Subject: 104a Sailplane Dihedral/Polyhedral Angles and Wing Span Calculations

Comet Sailplane Project

Wing Geometry Modified from Alfredo Herbon's CAD Drawing

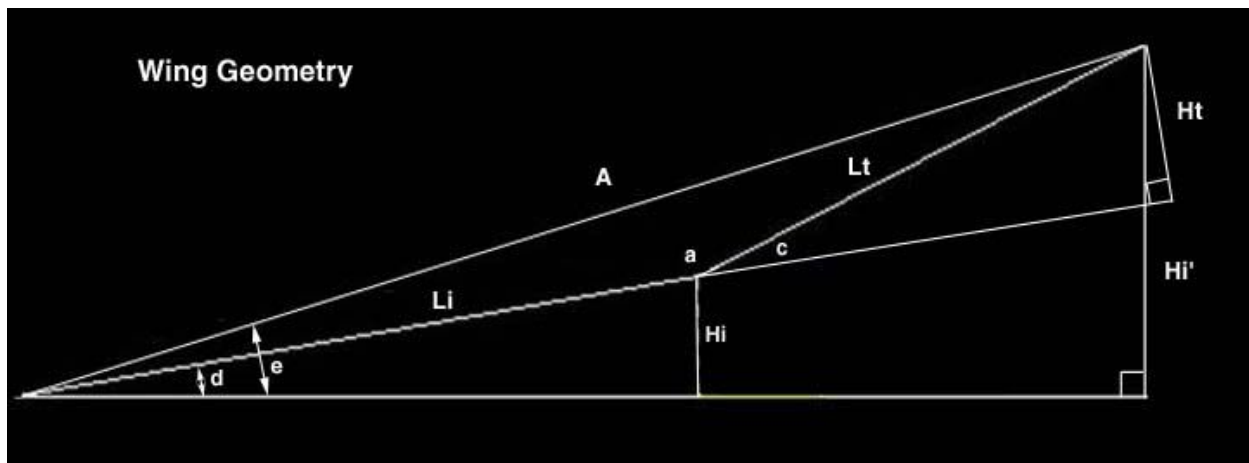
The other day after my calculations were finished and I was typing up my report, in the equation:

I left out a "2". The equation should read:

I also left out an "equal sign" in the equation:

The equation should read:

$$A^2 = (L_t^2 + L_i^2 - 2 L_t L_i \cos a)$$

$$\cos a = \cos(180-c) = -\cos c$$

I have made these corrections below. Please replace No. 104 with this revised Report No. 104a.....Tandy
